# Apparel Gallery Ltd.

23 March 2014

# Observations

**Heavy loading due to raised  
floor area on Ground Floor**

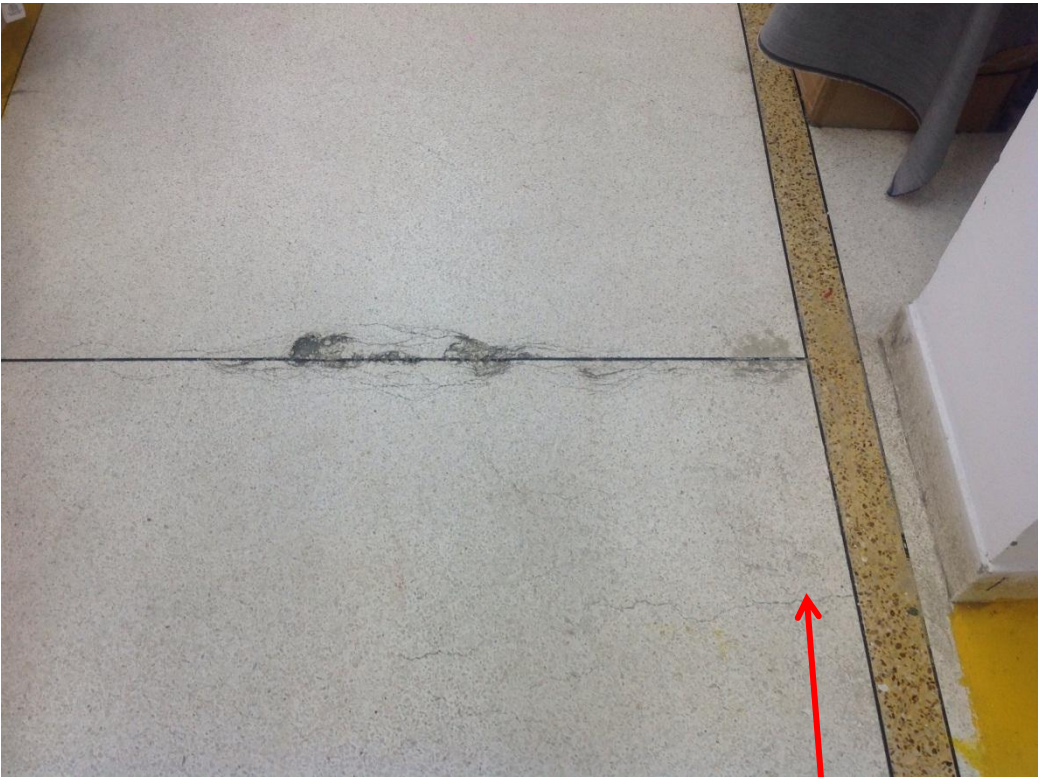
Raised floor area on top of raise area, not identified on drawings. Build up unknown.

Item No.	Observation	Recommended Action Plan	Recommended Timeline
1	Building 1 Heavy loading due to raised floor area on Ground Floor	A full Detailed Engineering Assessment is to be commenced for columns in the area of the raised platform at ground floor	<b>Immediate - Now</b>
2	Building 1 Heavy loading due to raised floor area on Ground Floor	Until DEA is complete reduce load at all levels to less than 1.5kN/m <sup>2</sup> and especially from stacked garments from area highlighted on page 5	<b>Immediate - Now</b>
3	Building 1 Heavy loading due to raised floor area on Ground Floor	At ground floor (grid B2-D4) remove the second lift of raised platform and investigate the construction of the lower platform. If found to be solid or filled with sand, remove material or evacuate areas above until structure and foundations proven.	<b>Immediate - Now</b>
4	Building 1 Heavy loading due to raised floor area on Ground Floor	Conduct concrete tests to prove concrete strength	<b>Immediate - Now</b>

**Repaired cracking in soffit of  
ground floor slab.**

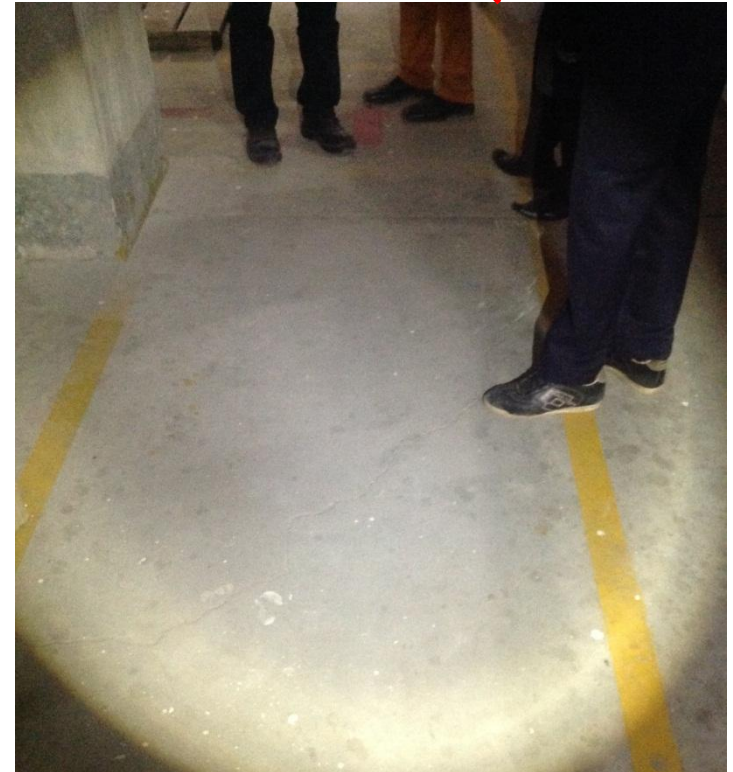
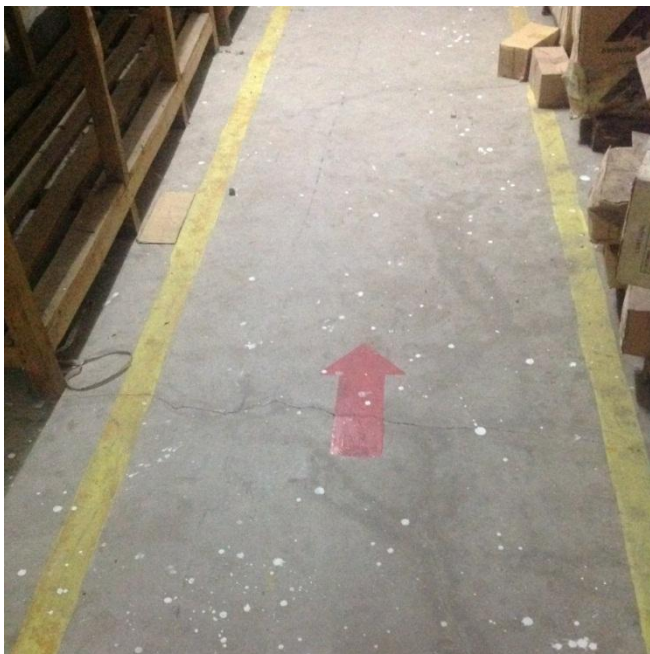
Recently repaired  
cracking in Soffit of  
ground floor slab  
adjacent to column  
with Basement  
slab cracking.

11	Evidence of repairs to cracks in soffit of ground floor under raised floor area's, repair should be removed by local engineer and reinforcement behind check for possible signs of corrosion	Repairs as detailed by the Building Engineer to be completed should investigations above reveal corrosion of reinforcement	6-months

## Water Storage

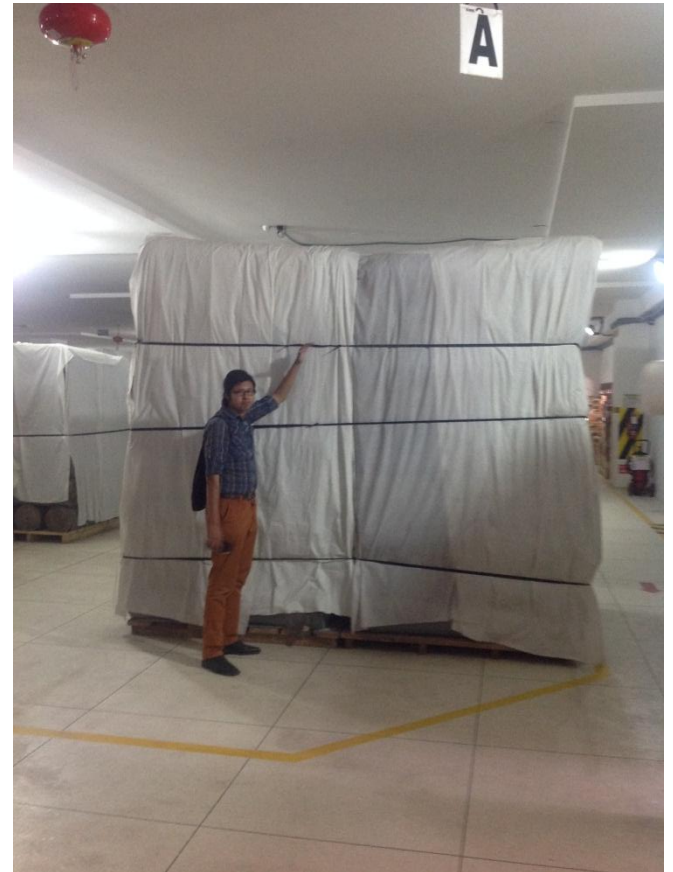
6 No. 2500L water tanks. (Currently not connected or filled)

## Floor Cracking

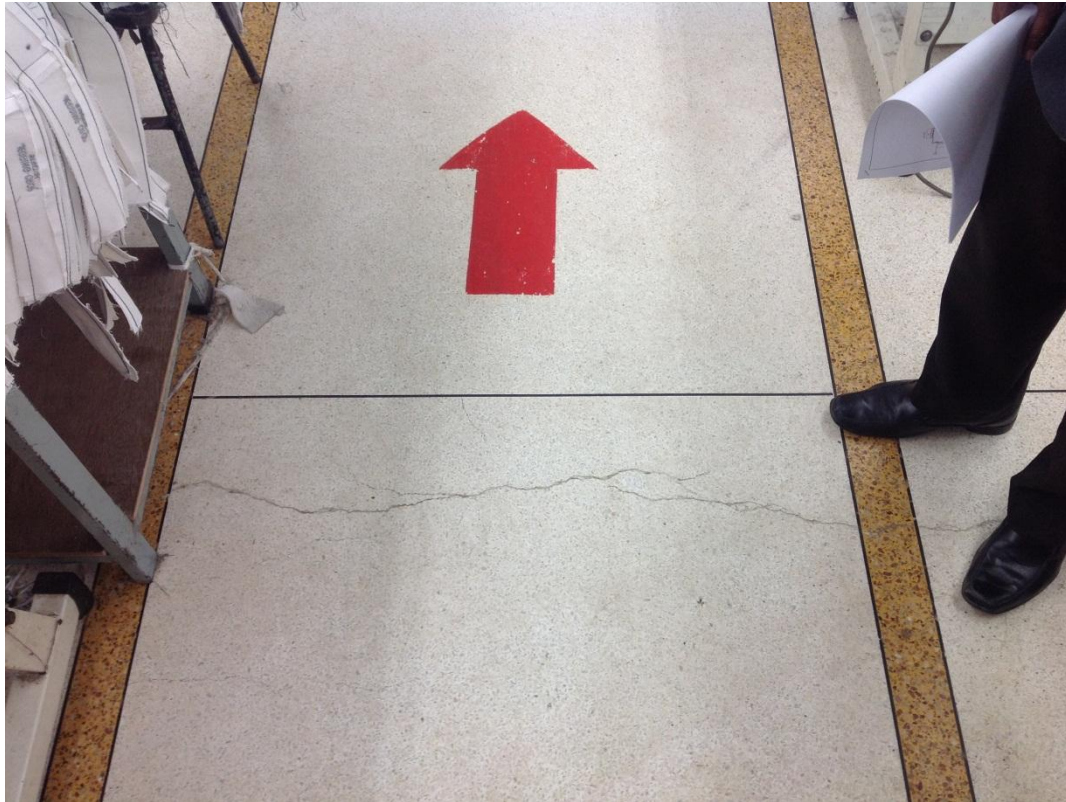
Cracking on  
column line.
